**Consumers
Power
Company**

March 23, 1976

DOCKET 50-255, LICENSE DPR-20
PALISADES PLANT, ANSWER TO
QUESTION ON LOCA (4.A.7)

Question 4.A.7

AVERAGE TEMPERATURE, HOT SPOT - DEG F

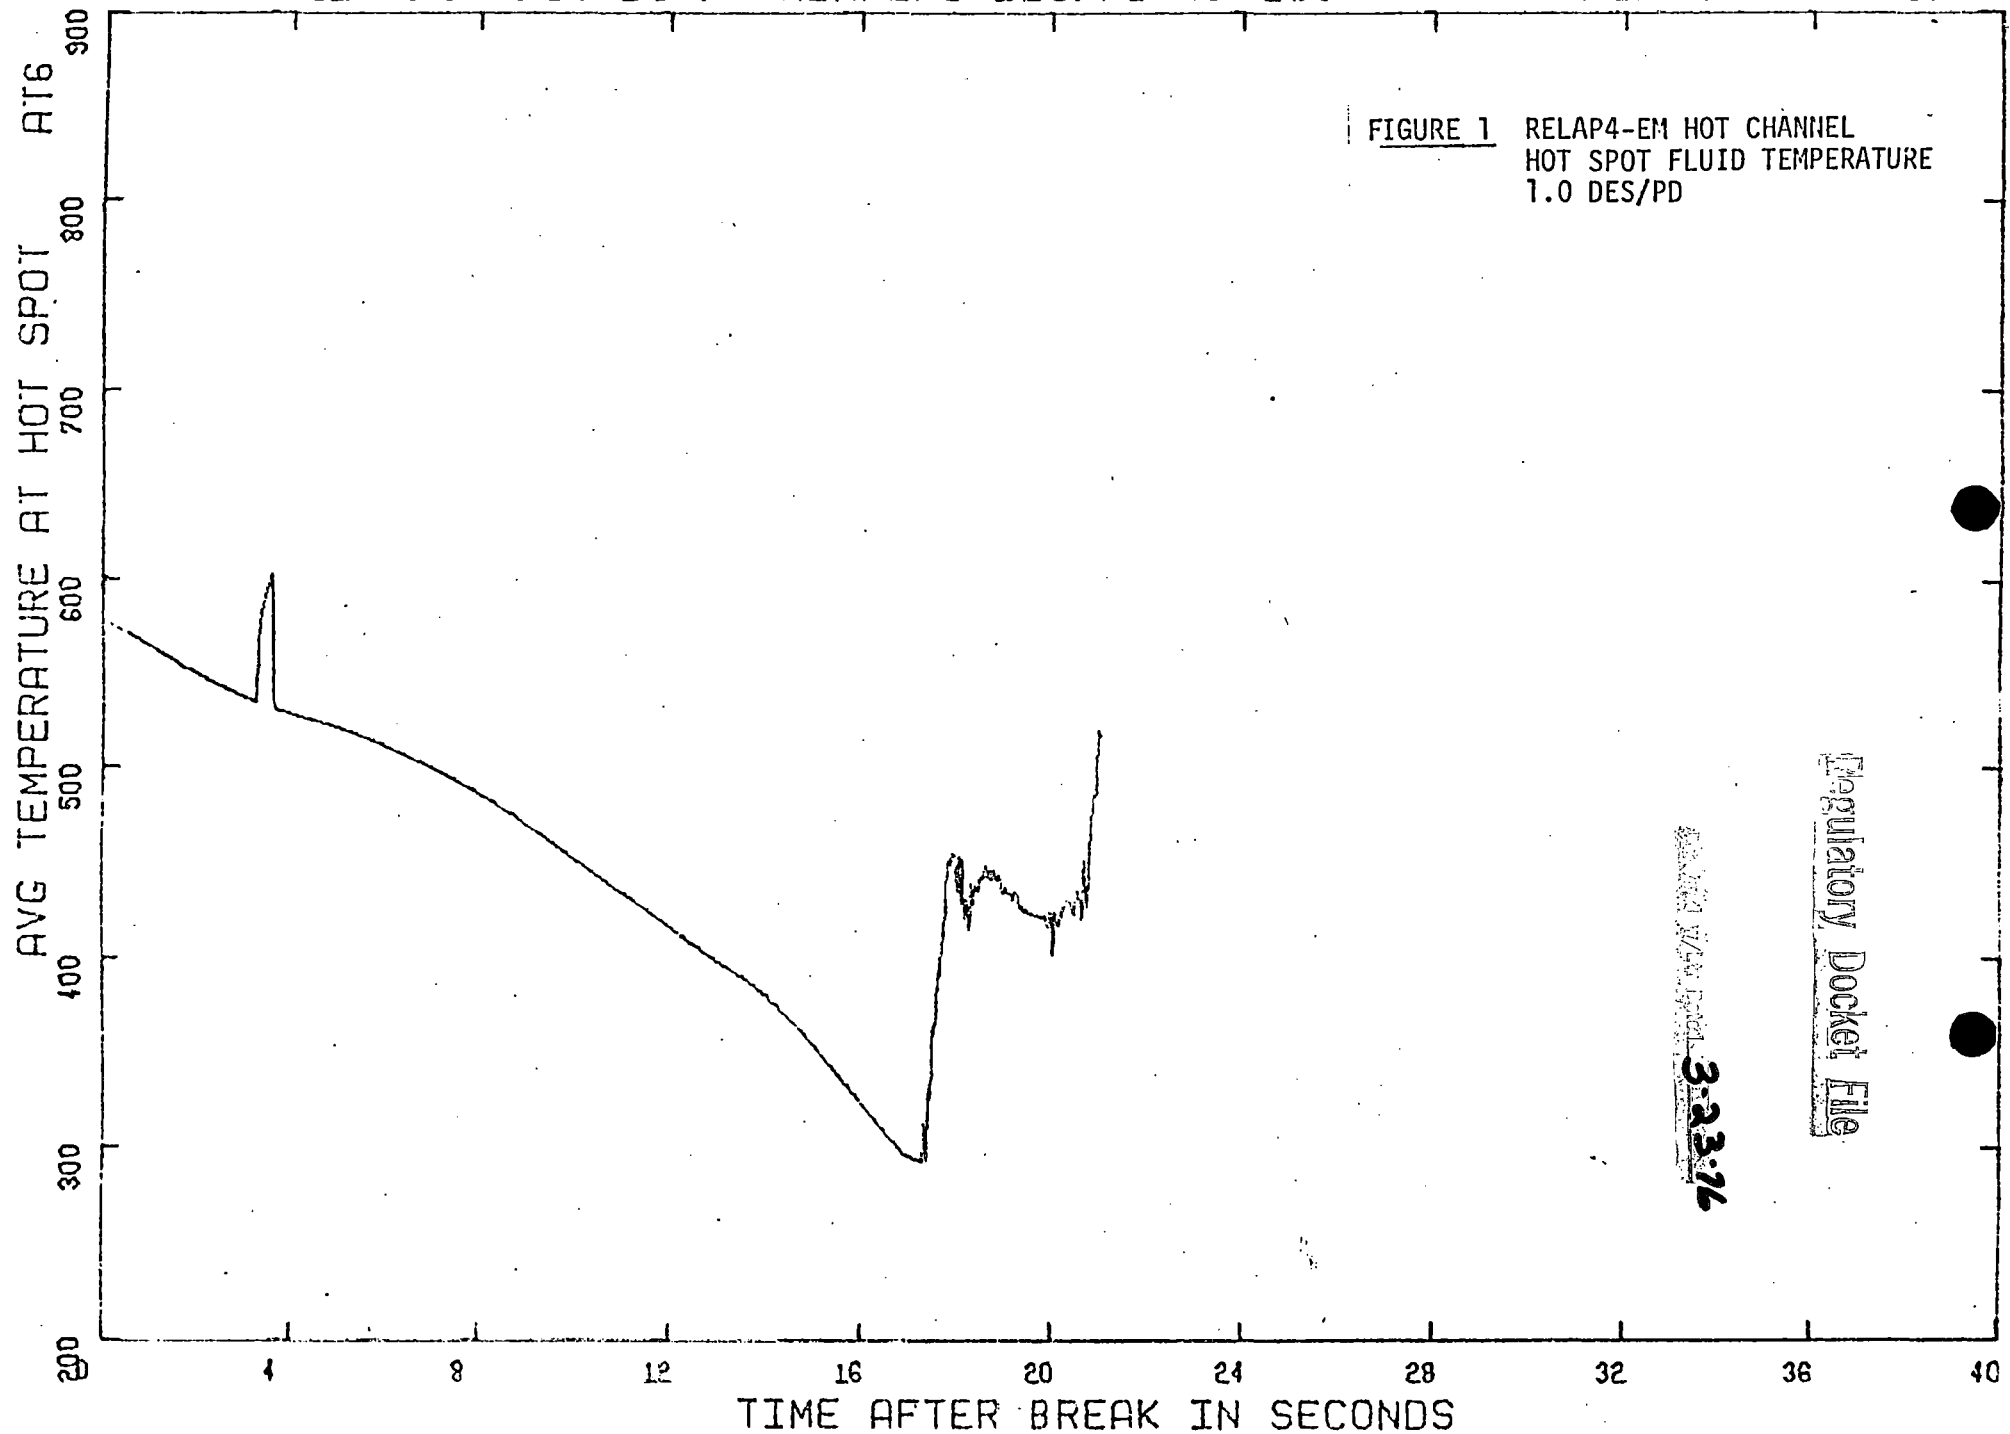
1. Reactor coolant temperature versus time at the hot spot.
2. Average fuel temperature at the hot spot.
3. Hot assembly flow rate.
4. Quality at the hot spot.
5. Gap conductance versus time at hot spot.
6. Hot rod internal pressure.
7. Rupture time.

1. The average fluid temperature in Volume 6 of the hot channel model (Figure 1).
2. The volumetric average fuel rod temperature for heat transfer Node 22 of the hot channel model (Figure 2).
3. Hot assembly flows at inlet Junction 10 and outlet Junctions 11 and 12 for the hot channel model (Figures 3, 4 and 5).
4. Average quality of Volume 6 of the hot channel model (Figure 6).
5. Gap conductance for the maximum power node for both blowdown and reflood and gap conductance for the PCT node during refill and reflood (Figures 7 and 8).
6. The hot rod pin pressure during the entire transient (Figure 9).
7. Rupture time for the 1.0 DES/PD was calculated to occur at 49.82 seconds after the break.
